RFI 5

Project: COOLEY LABORATORY RENOVATION
Job: 3146 COOLEY LAB, PPA# 10-0023
Customer: STOFMT MONTANA STATE UNIV. BOZEMAN

Item: CANOPY AT DOOR 106
Reference: A4.0, 4/A3.1, 5/S3.2, S2.2
Attachments: 2 PICTURES

F-2

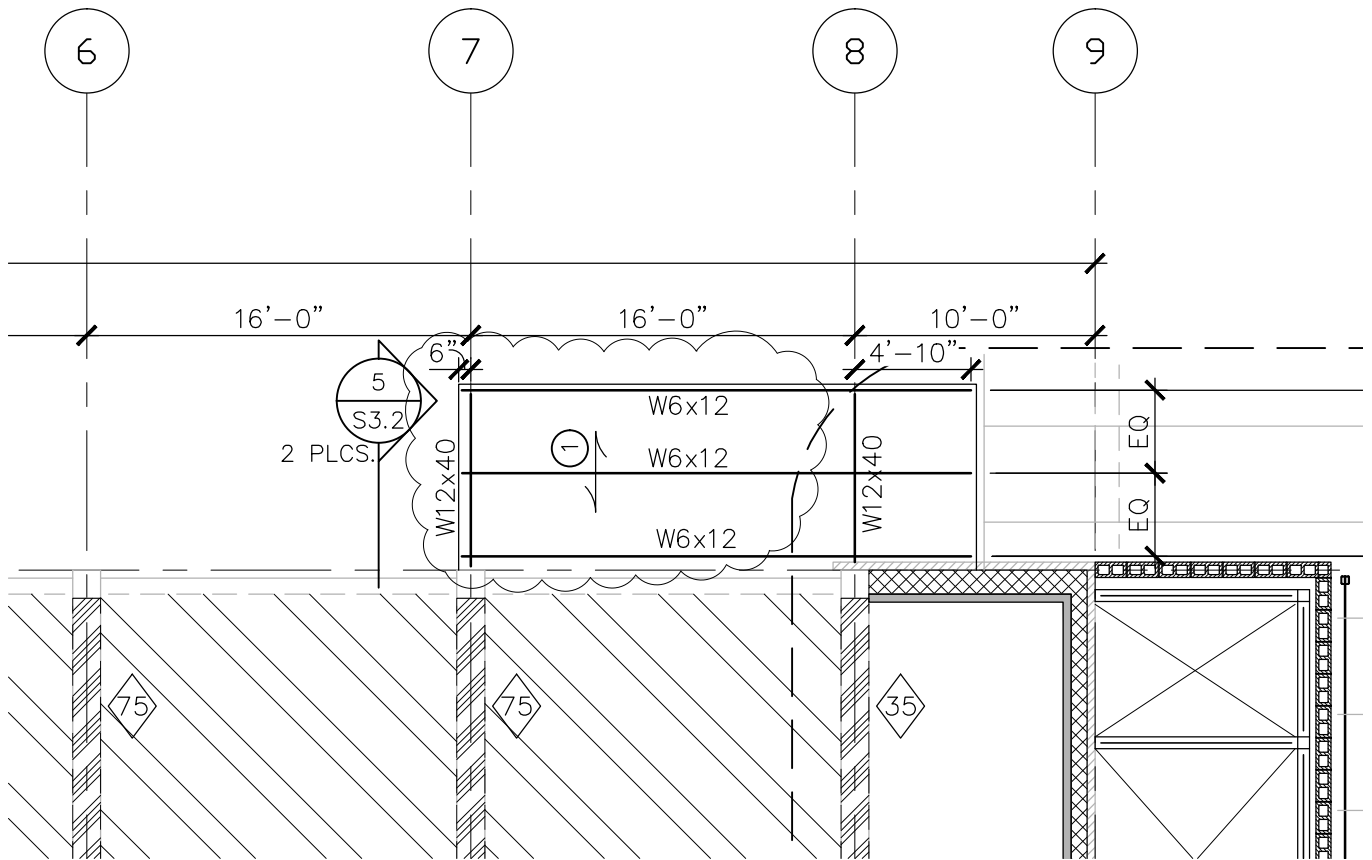
Question:
Detail 5 on S3.2 shows the knee braces of the canopy at door 106 being connected back to the building at locations that have concrete walls. The concrete wall ends at gridline 8 as shown on sheet A1.3. Thus the knee brace west of door 106 will be connected to a pier of CMU not concrete.

Recommendation:
Currently the the top of canopy elevation is shown at an elevation of 122'-6", The top of the concrete floor beam elevation is 120'-6". We would recommend lowering the top of the canopy elevation 2'-0" so the W beam of the canopy is connected into the concrete floor beam. We would recommend designing a column support to replace the strut of the knee brace on the West knee brace or both. Or designing a structural canopy support system that is independent from the building structure.

EXTEND CANOPY SO THAT WEST SUPPORT IS AT GRID LINE 7. SEE ATTACHED FIELD DRAWING F-2.
